WELLINGTON PREPARATION PLANT

C/007/012

INSERTABLE INFORMATION FOR THE MINING & RECLAMATION PLAN

Comments & Instructions
for Insertions to the Mining & Reclamation Plan
of the Wellington Preparation Plant
C/007/012

WELLINGTON PREP PLANT			
STIFF DIAGRAMS OF SELECTED WATER SAMPLES COLLECTED FEBRUARY 2006			
			DATE DRAWN 8/03/06
DESIGN BY KK	DRAWN BY CP		REVISION

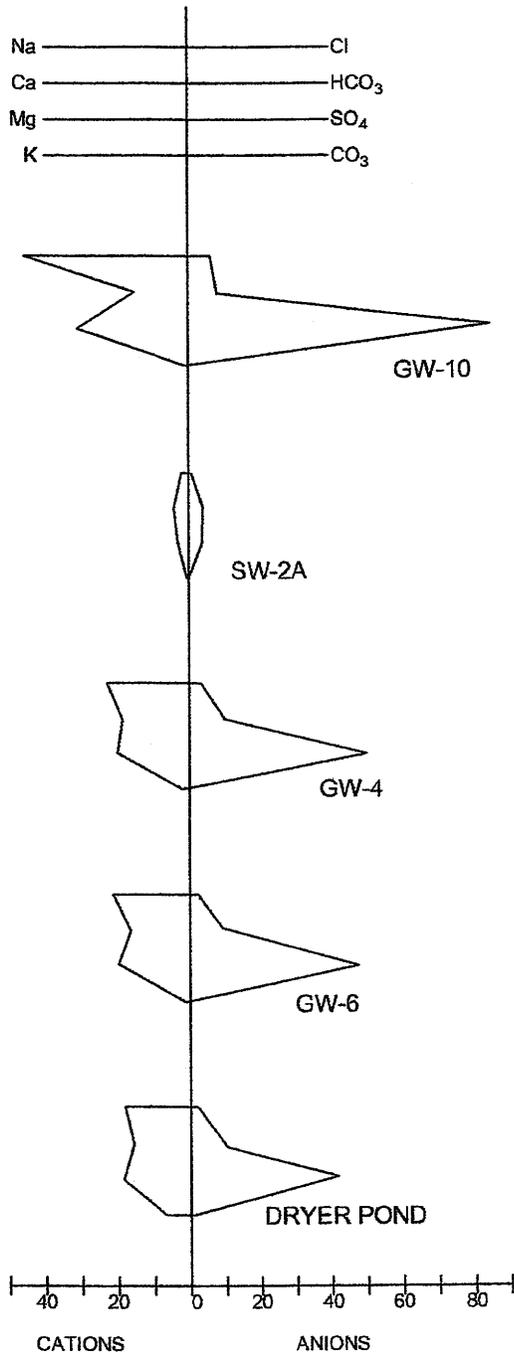
An examination of water quality also supports this conclusion. In February 2006, routine 1st quarter surface and groundwater monitoring was supplemented by collecting a sample from the Dryer pond. (A Dryer pond sample was also collected during the 3rd quarter monitoring but results have not yet been reported.) Stiff diagrams were prepared for relevant sites, and are attached. These drawings show the ionic composition of the waters; those with similar shapes and sizes indicate water with a similar makeup and ionic strength. As shown, water entering the Dryer pond is almost identical to water sampled from GW-6 and GW-4, the monitoring wells closest to the Price River pump house site. Water obtained from the Price River is dissimilar both in make-up and strength. Water from GW-10 near the Dryer Pond has a similar ionic make-up but is much more concentrated. As with the elevation data, the water quality data suggest that the source of the Dryer pond is the alluvial groundwater near the pump house site.

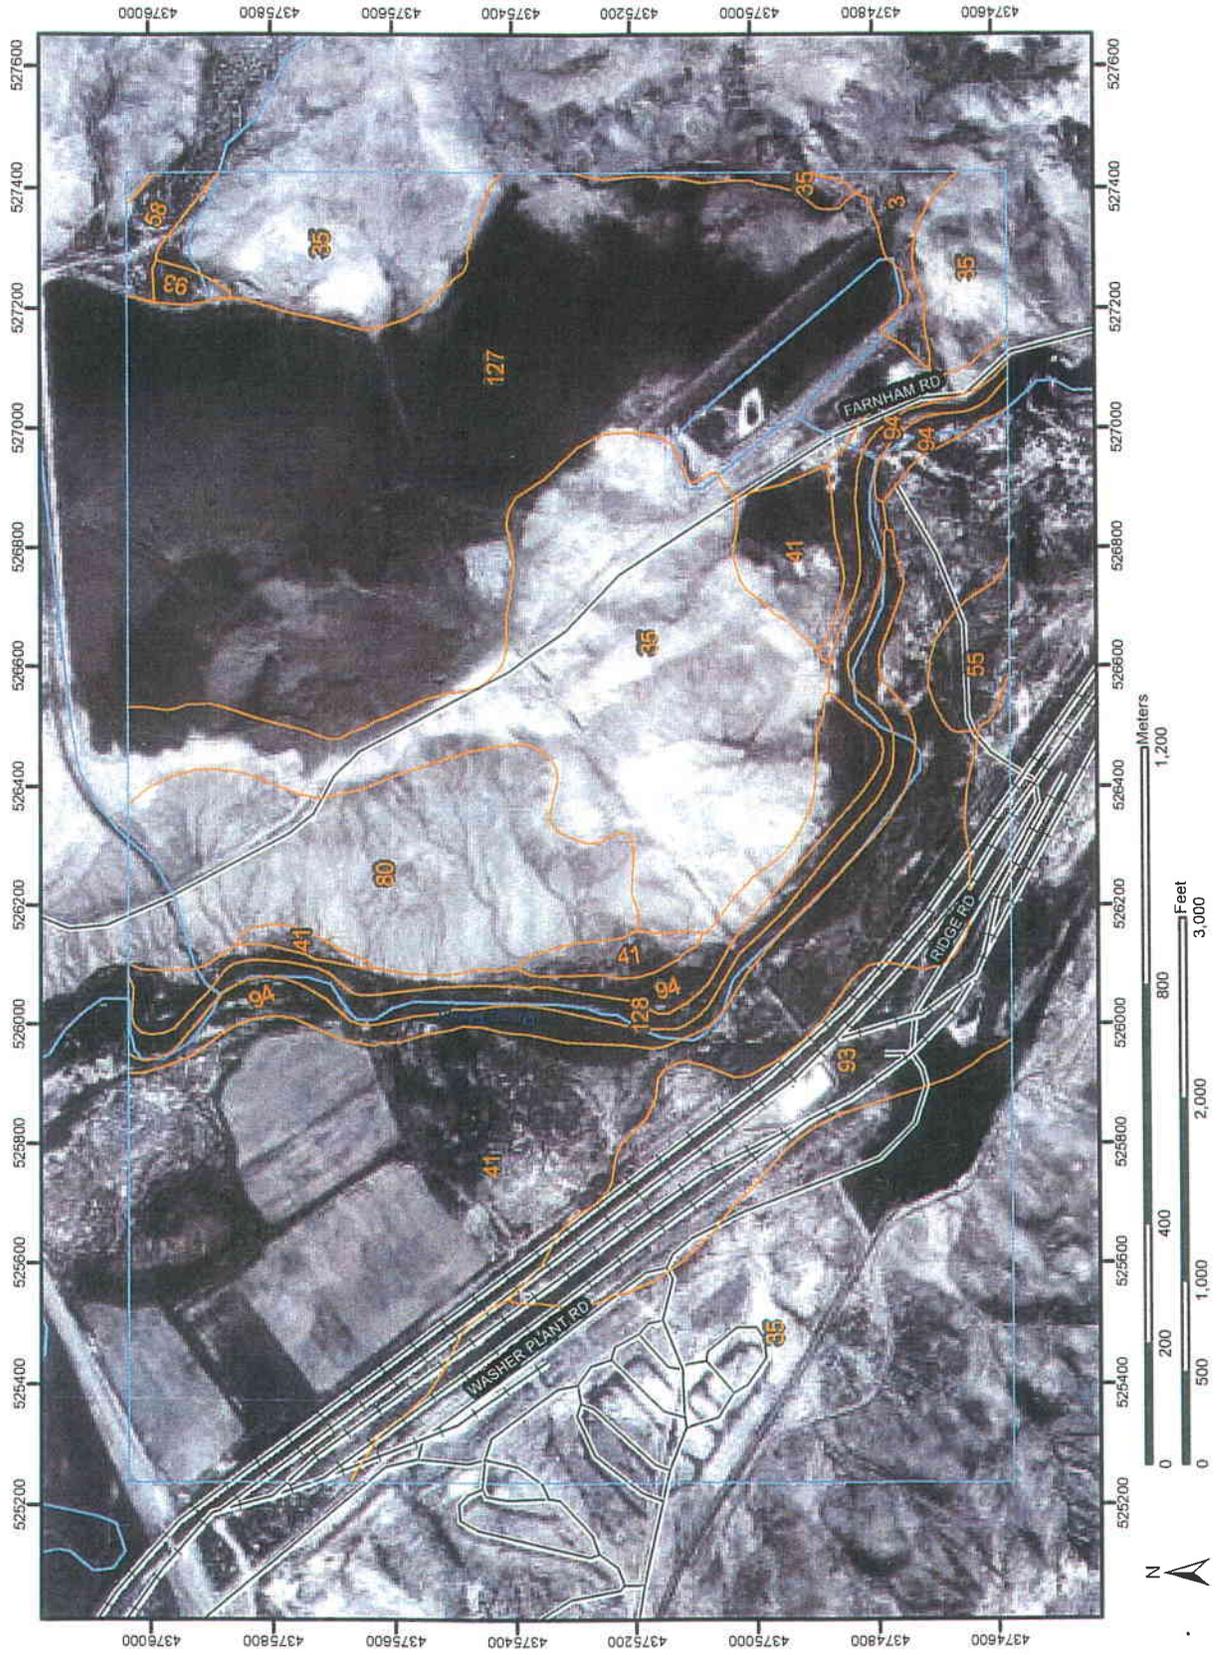
R645-301-541.400 and R645-301-542, The reclamation must include (certified) maps or drawings or other information to show the location of the reclamation disturbance and how the Permittee will comply with environmental protection standards or a timetable for reclamation.

Reclamation of the area has been described in Response "E" above. In the description provided above regarding sealing of the pipeline it is stated that the exact location for these activities will only be known at that time. Consequently, certified as-built maps with the location of these activities will be provided at that time.
